Bulletin No.: L03-001  
Release Date: 02/24/03  
Effective Date: Immediately  
Supercedes: N/A  
Completion Date: 03/31/03  
Page: 1 of 4

# SERVICE BULLETIN

Ride Manufacturer: Larson International, Inc. Affected Production Dates: All  
Ride Name: Ring of Fire & Fire Ball Affected Serial Nos.: All units

Addition of a positive lock to secure the train in an inverted position in order to increase safety during the inspection process.

# MODIFIED INERTIA SECTION

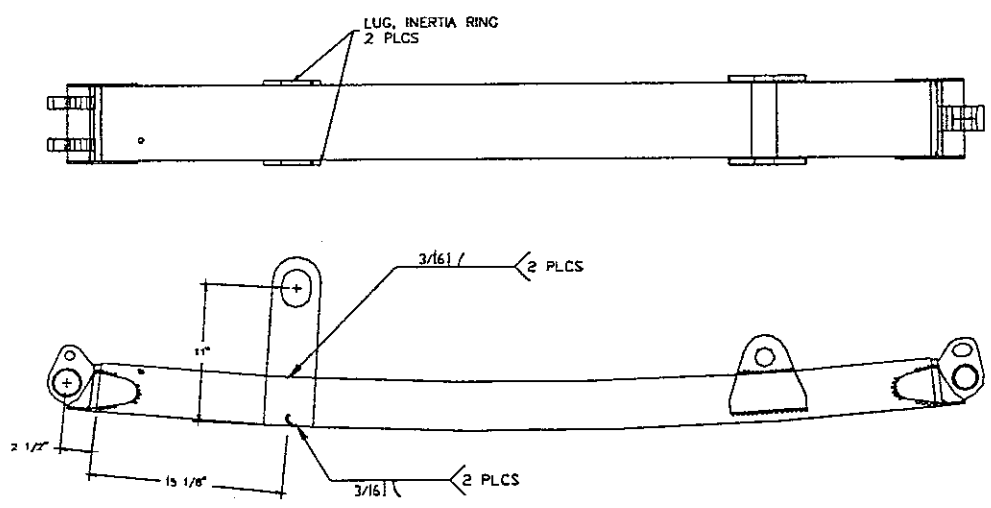
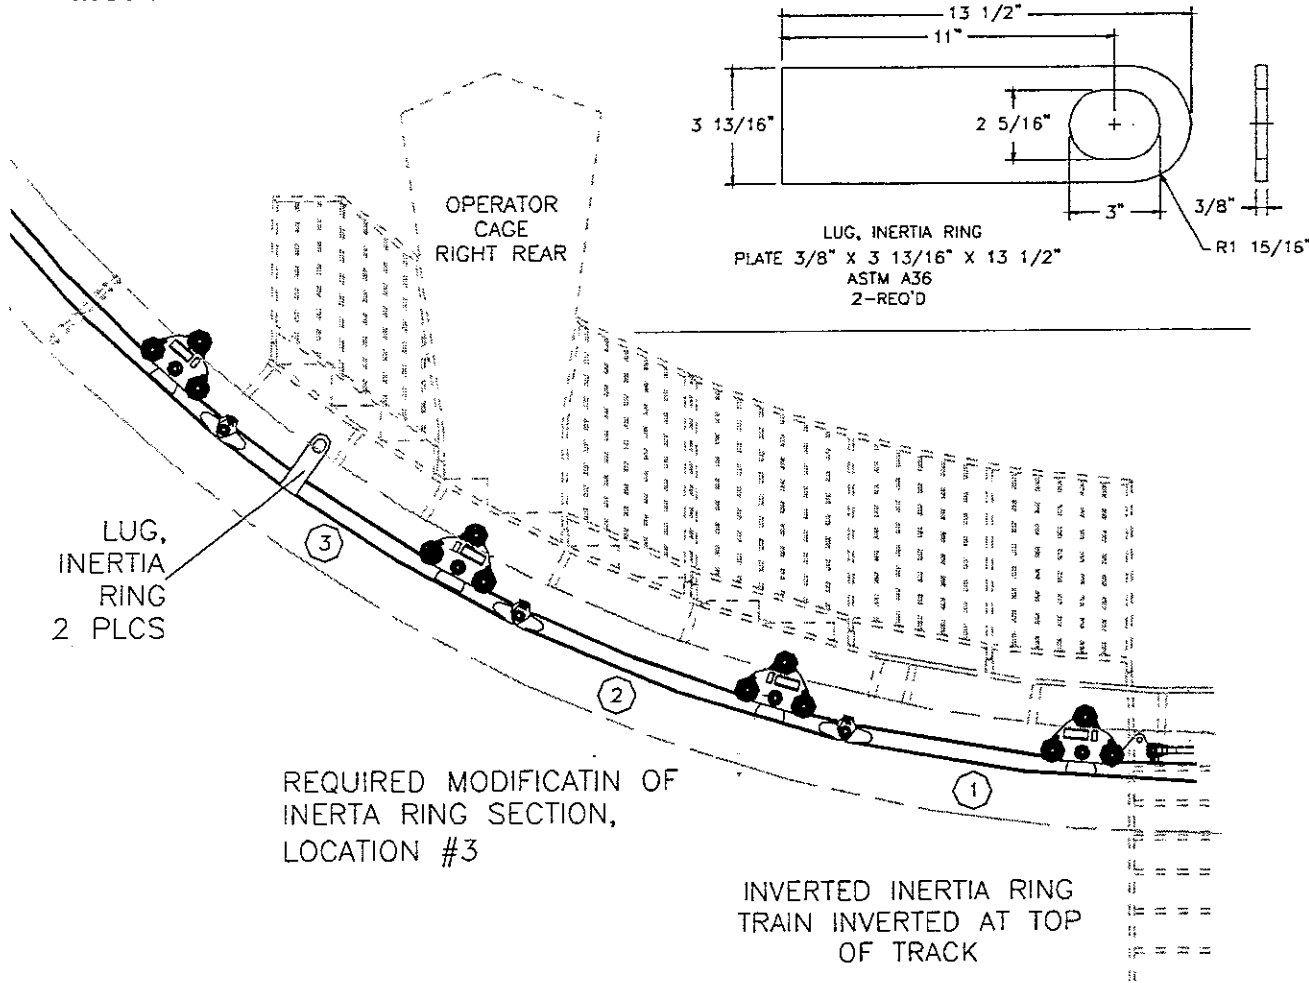
Add inverted positive lock.

A certified welder must complete all welds.

**Caution:** Inertia section contains 1/2 quart of oil. Welder must be aware of this condition.

# MODIFIED TRACK SECTION

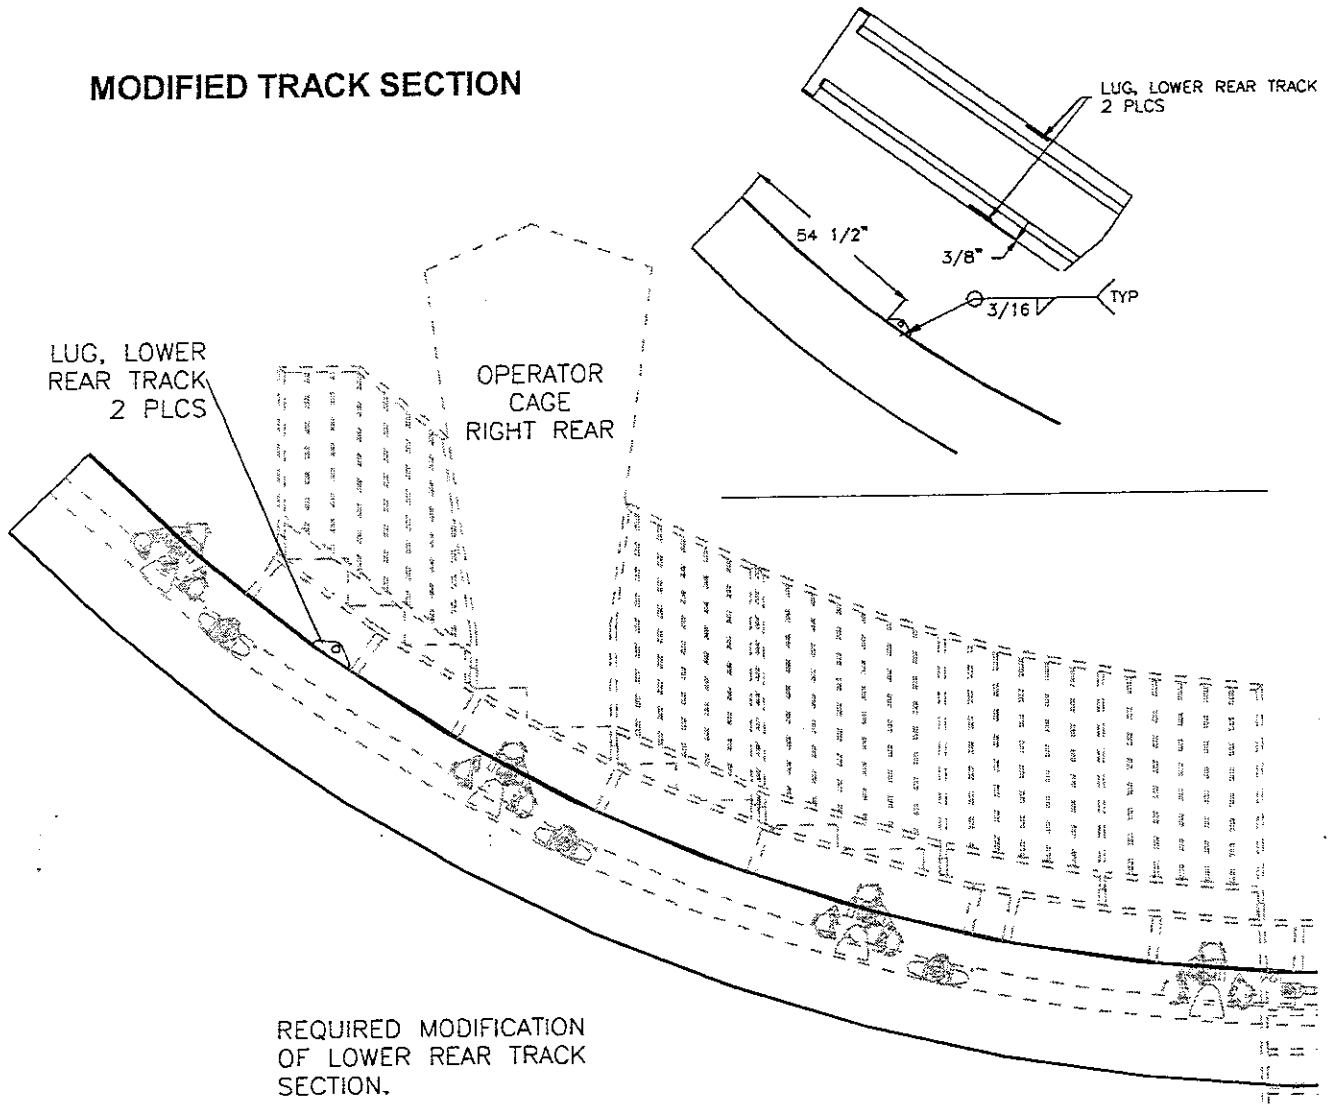
LUG, LOWER REAR TRACK  
PLATE 1/2" X 3" X 7 1/2"  
ASTM A36  
2-REQ'D
